Text of ECE/TRANS/WP.29/GRSG/2012/15 as **adopted** during 104th GRSG

**Draft 06 series of amendments to Regulation No. 107
(M₂ and M₃ vehicles)**

Model A

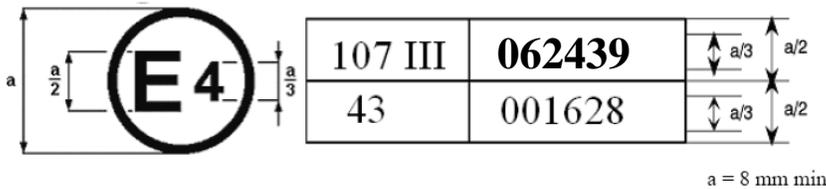
Annex 2, amend to read:

The above approval mark under approval number 062439. The approval numberas amended by the 06 series of amendments.
